# Access Compliance Report

## Public Rights-of-Way

Intersection ID: 49383	Main Street: CORRIENTE_CT	Cross Street: SOUTH_DEVON_ST	Location: E
ADA ID: 3F3393747A43	Ramp Type: PerpDiag	Initial Pass/Fail: Fail	Overall Compliance: No
		Severity Score: 12.5

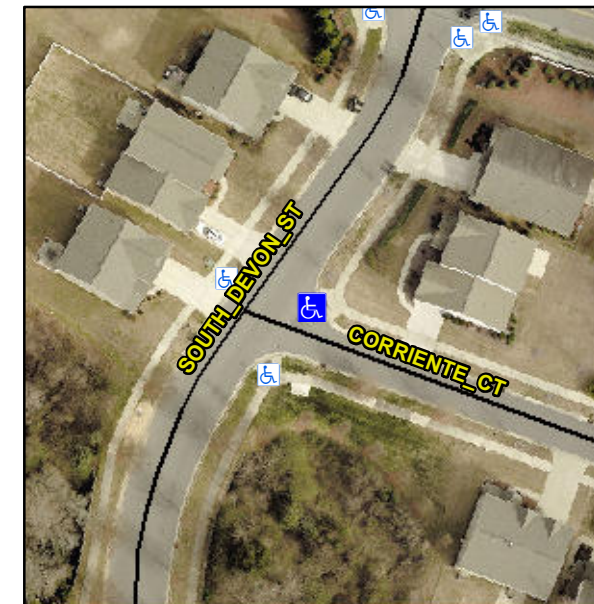
**Not Found, R304.2.2**

Compliance	Description	Data	Compliance	Description	Data
N/A	Ramp Length (in)	84.5	No	Ramp Slope (%)	10.5
Yes	Ramp Width (in)	48.0	Yes	Ramp XSlope (%)	1.8
N/A	Flare Type LT	N/A	N/A	Flare Type RT	N/A
N/A	Flare Slope LT (%)	N/A	N/A	Flare Slope RT (%)	N/A
N/A	Flare Traversable LT?	N/A	N/A	Flare Traversable RT?	N/A
N/A	Landing Length (in)	N/A	N/A	DWS Provided?	N/A
N/A	Landing Width (in)	N/A	N/A	DWS Contrast?	N/A
N/A	Landing Slope (%)	N/A	N/A	DWS Length (in)	N/A
N/A	Landing X Slope (%)	N/A	N/A	DWS Full Width?	N/A
N/A	Landing Curb? (Y/N)	N/A	N/A	DWS Offset (in)	N/A
N/A	Shared Landing?	N/A			
N/A	Gutter Ponding?	N/A	N/A	Gutter Slope (%)	N/A
N/A	Gutter Lip Ht (in)	N/A	N/A	Gutter X Slope (%)	N/A
N/A	Painted X Walk1?	No	N/A	Painted X Walk2?	No
	X Walk 1 Direction	To NW		X Walk 2 Direction	To SW
N/A	X Walk 1 Width (in)	N/A	N/A	X Walk 2 Width (in)	N/A
	X Walk 1 Slope (%)	0.9		X Walk 2 Slope (%)	1.1
	X Walk 1 X Slope (%)	1.0		X Walk 2 X Slope (%)	3.2

**Remove & Replace Curb Ramp With Two New Directional Ramps or Equivalent.**
